Flight Procedures Cover Page	Task Action: FLIGHT CHECK	Task Type: IAP	Estimated Chart Date: 07/14/2022	APWS Task ID: E340E0EBEA044A5BBD98D9DD73EC9D64	APWS Project ID: B10BFC5F57EC4CA2BF592B75332BCF98
Procedure: ILS V RWY 13R ORIG		Enroute: NO	Specialist: Cappabianco, Anthony		Agreement Number:
Airport ID: KDFW			Airport City: DALLAS-FORT WORTH		State: TX
Facility ID: LWN	Facility Type: ILS	Flight Inspection Remark Type: New FC Slot			
<p>Procedure Comments: CONTACT CASIMIR TABAKA 405-954-7931.</p> <div style="text-align: right;">  <p>Digitally signed by MARK D ADAMS Mar 17, 2022</p> </div>

KDFW
Dallas-Fort Worth Intl
Dallas-Fort Worth, TX
ILS V RWY 13R (CONVERGING), ORIG

Requesting approval for KDFW ILS V RWY 13R (CONVERGING) to have a speed restriction in the missed approach not due to obstacles.

CONVERGING ILS V RWY 13R

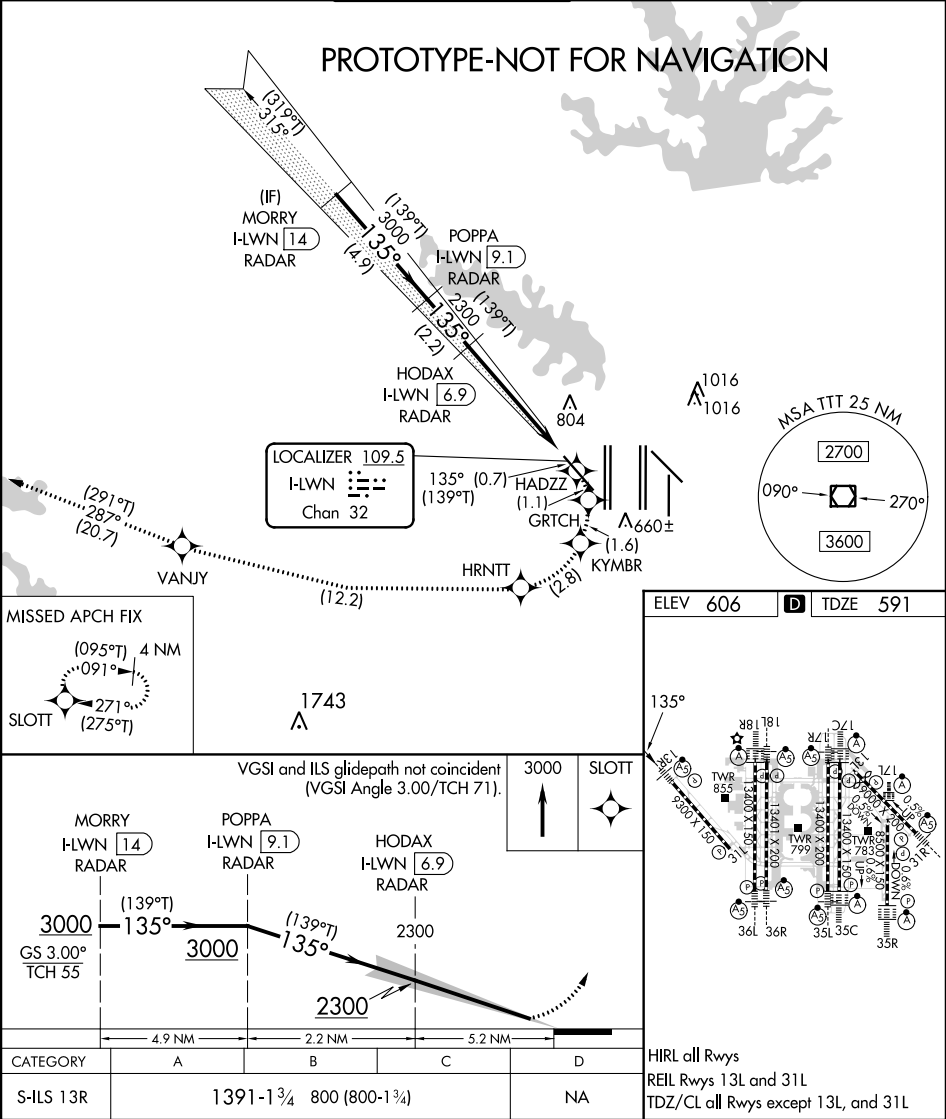
Requesting approval for KDFW ILS V RWY 13R (CONVERGING) to utilize an A-RNP missed approach with XTT less than 1.

FAAO 8260.58B Table 1-2-2, Note 2 states "approval is required for missed approach restrictions for other than obstacle avoidance." At FPT/ATC request, the KDFW ILS V RWY 13R (CONVERGING) missed approach will match that of the already approved KDFW RNAV (RNP) Z RWY 13R missed approach which utilizes a speed restriction of "DO NOT EXCEED 185 KIAS UNTIL HRNTT."

FAAO 8260.58B 4-3-1 states "se of A-RNP missed approach XTT less than one requires Flight Standards approval." At FPT/ATC request, the KDFW ILS V RWY 13R (CONVERGING) missed approach will match that of the already approved KDFW RNAV (RNP) Z RWY 13R missed approach which utilizes an XTT of 0.3 per 8260.58B Table 1-2-1.
